**In re: City of Alexandria Planning Commission public hearing - January 6, 2009
Docket Item No. 9 - CDD Concept Plan #2008-0004
Docket Item No. 8 A & B – Development Special Use Permit #2006-0018(A) and
Coordinated Sign Program SUP #2008-0089(B)**

***Docket Item #8 A & B
Development Special Use Permit with Site Plan #2006-0018
Coordinated Sign Program SUP #2008-0089
Potomac Yard – Landbays I & J***

Purpose of Application
Development of 227 townhouse and stacked townhouse units on a portion of Landbay I and on a portion of Landbay J in the Potomac Yard Coordinated Development District (CDD#10).

Attachment #7

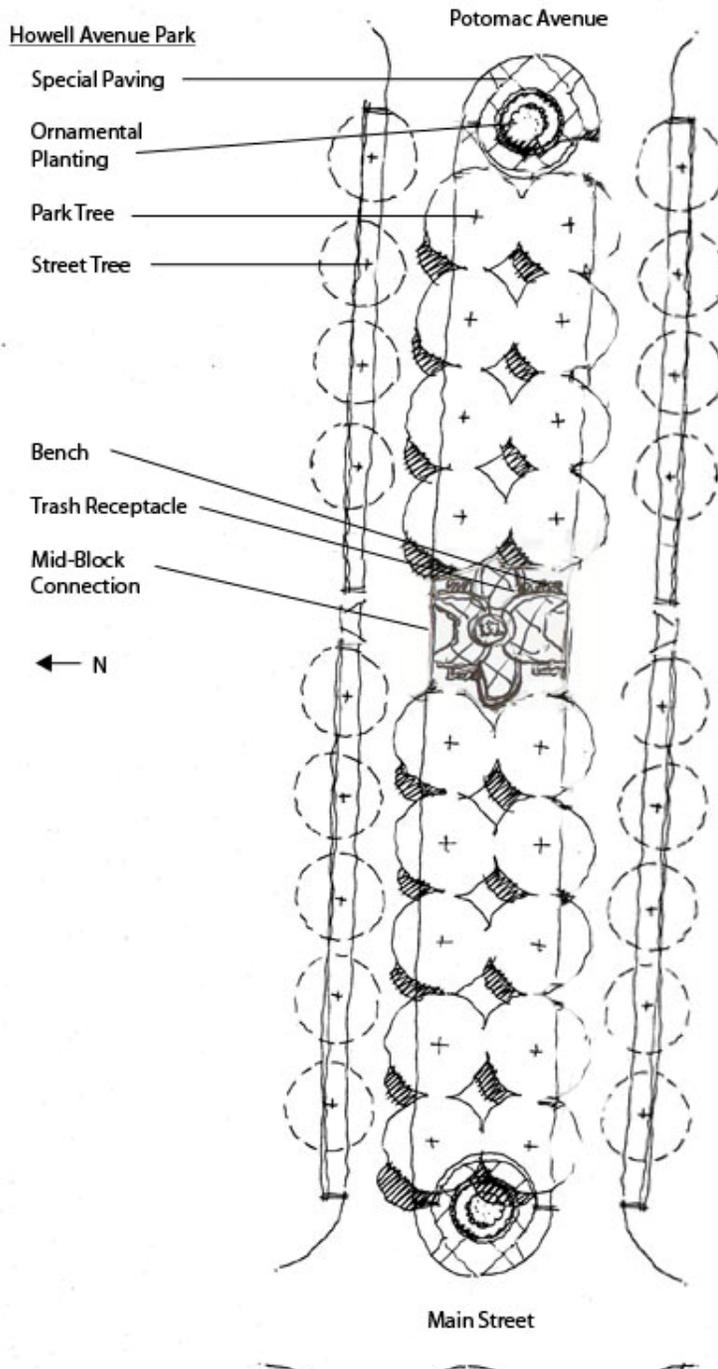
10. ***Custis Finger Park:*** The park shall be revised to provide the following to the satisfaction of the Directors of RP&CA and P&Z:
- a. The park shall be revised as generally depicted in Attachment # 7.

- b. Revise the spacing of the park trees to 30 feet on center, as approved in DSUP 2004-0048, and provide an additional four (4) shade trees. Street trees along Custis Avenue shall be parallel the length of the street.

- c. Provide eleven (11) ornamental trees in the portion of the finger park west of Main Street.
 - d. Freestanding signage shall be prohibited.
 - e. Two City standard trash receptacles shall be provided within the park.

Attachment #8

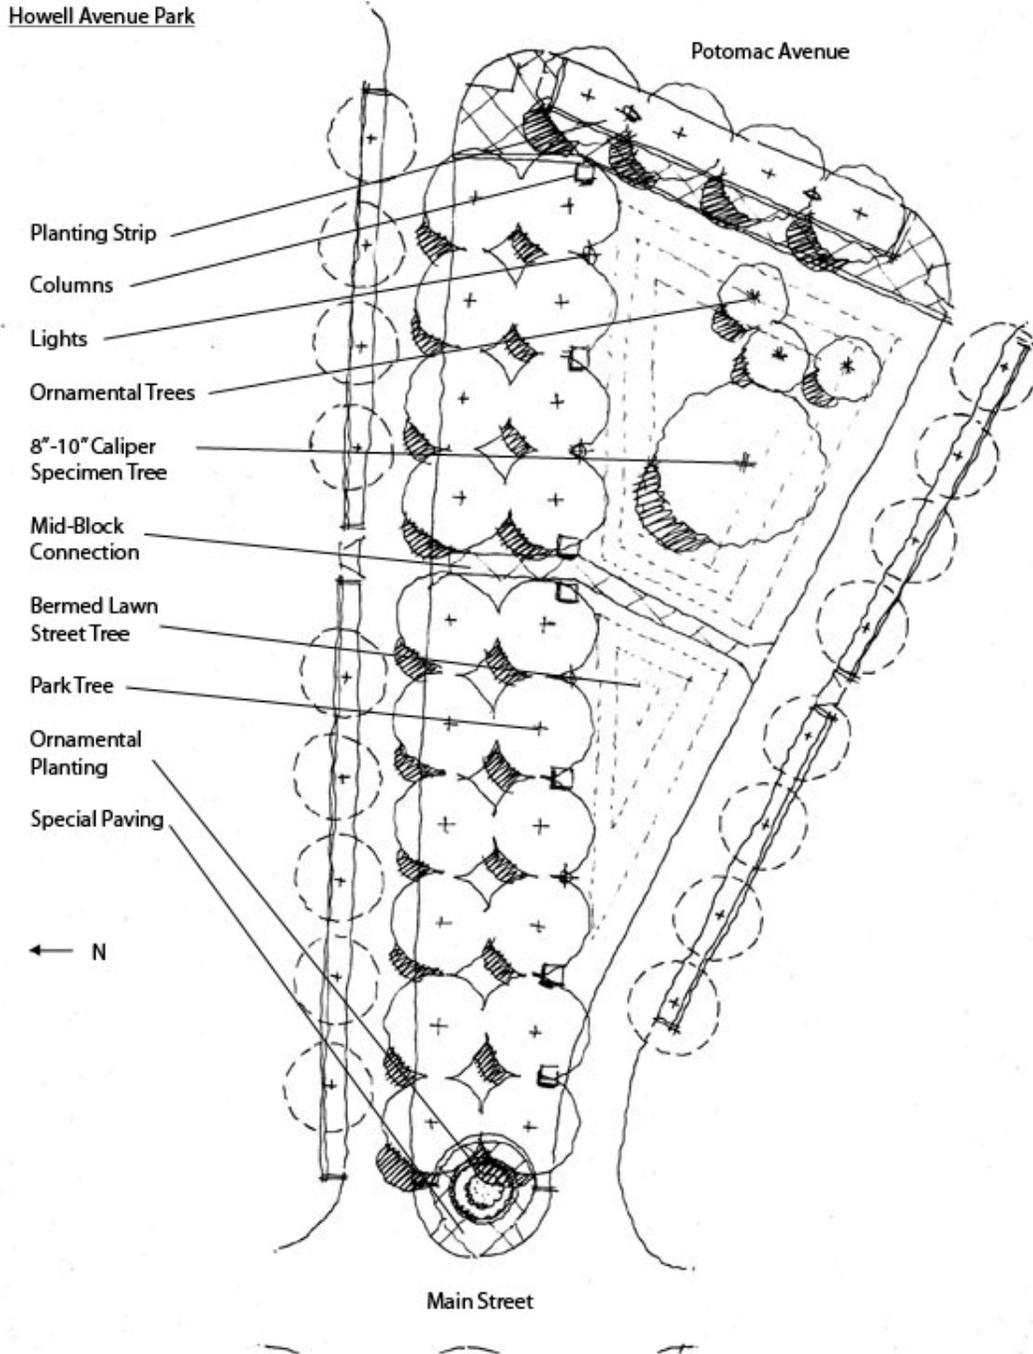
11. ***Howell Finger Park:*** The park shall be revised to provide the following to the satisfaction of the Directors of RP&CA and P&Z:
- a. The park shall be revised as generally depicted in Attachment # 8.

- b. Revise the spacing of the park trees to 30 feet on center to provide an additional fourteen (14) shade trees.
 - c. Provide eleven (11) ornamental trees in the portion of the finger park west of Main Street.
